SERVICE BULLETIN No.1095

COACH MODEL	: C2045
BULLETIN TYPE	: Service Information
MANUAL & SECTION	: Maintenance Manual: Chapter 10 - HVAC System Spare Parts Manual: Section 771809 - Heating accessories
PARTS BOOK REVISION	: Yes
DATE	: November 30th, 2001
SUBJECT	: Proheat combustion heater – carbon build-up
TERMS & CONDITIONS	: No claims will be accepted with reference to this Bulletin.

Figure 2: Heat shield installation between Proheat exhaust and shock absorber on C-beam

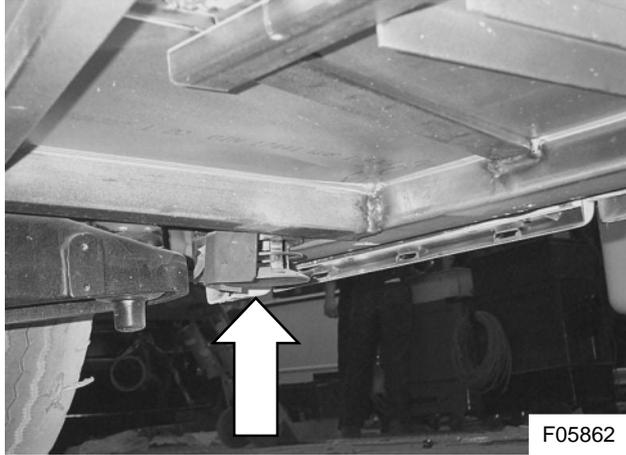
- Refer to the nozzle sealing washer installation procedure if an air leak has been detected.
- Tests at Van Hool have shown that the deflector at the base of the shock absorber behind the exhaust pipe (see Figures 1 and 2) increases the exhaust back pressure, thus reducing the exhaust gas flow and contributing to a certain extent to the carboning also.

- Removing the shield also increases time between service intervals.
- Van Hool recommend removal of the heat shield during the next service interval to improve combustion heater performance. The procedure in this Bulletin explains how this can be done.

4. To remove exhaust heat shield VH 10715349 (see Figure 2):

- 1) Underneath the coach, locate the Proheat combustion heater exhaust pipe and heat shield (see Figure 2).

Figure 3: Exhaust heat shield, nut and bolt to be removed

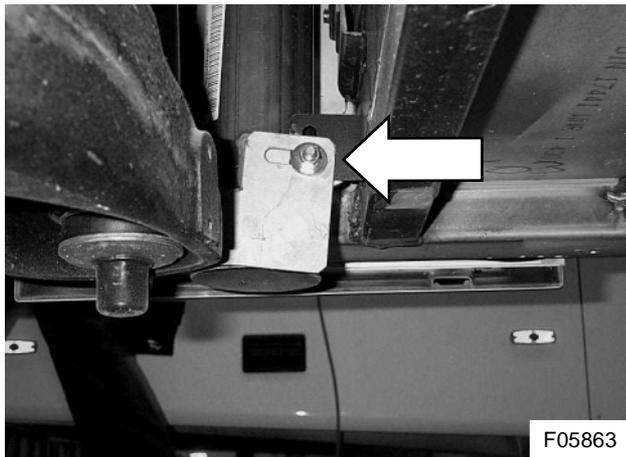
- 2) Using two 13 mm box wrenches, undo and remove the bolt, nut and washers securing the exhaust heat shield to the chassis mounting bracket (see Figure 3).

- 3) Remove and discard the heat shield.

Figure 1

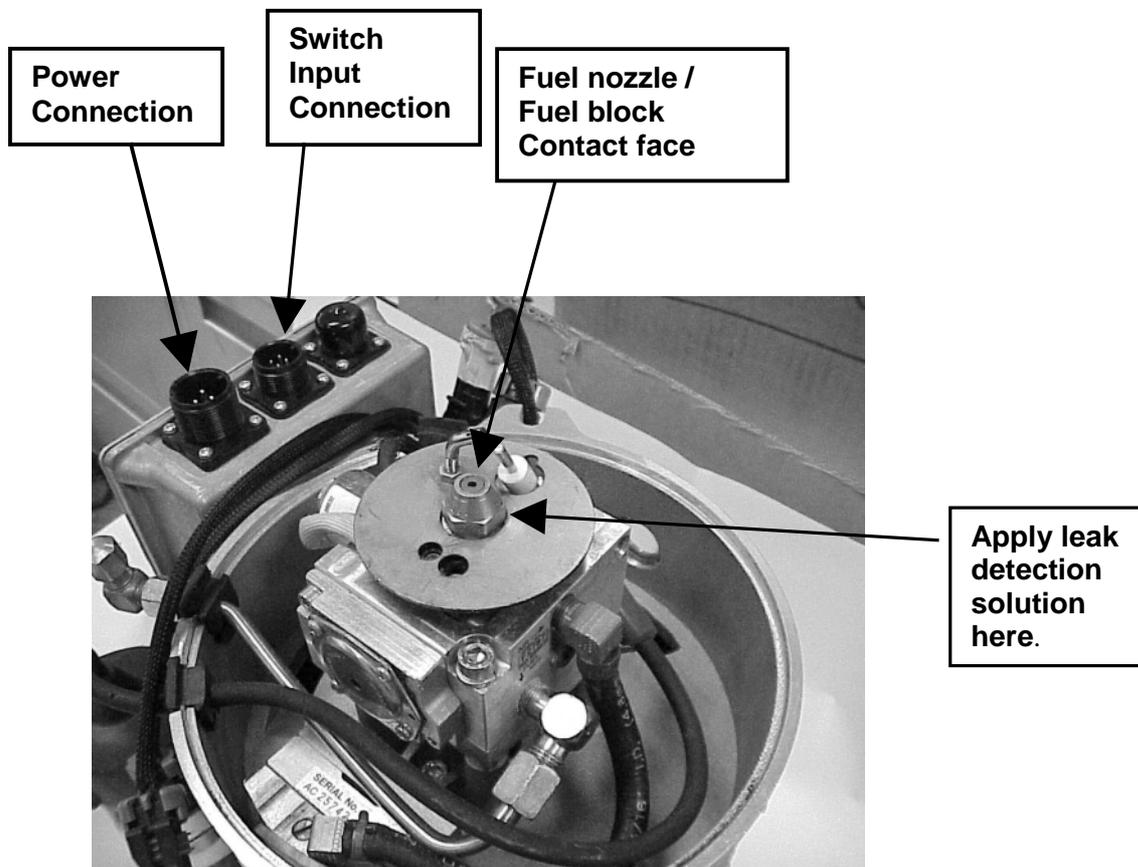
4. While the heater is running in purge cycle (3 minutes), test for air leaking between the back of the fuel nozzle and the fuel block using a leak detection solution. See Figure 1.
 - If an air leak is detected install washer seal PK0361 (c/w Instructions).
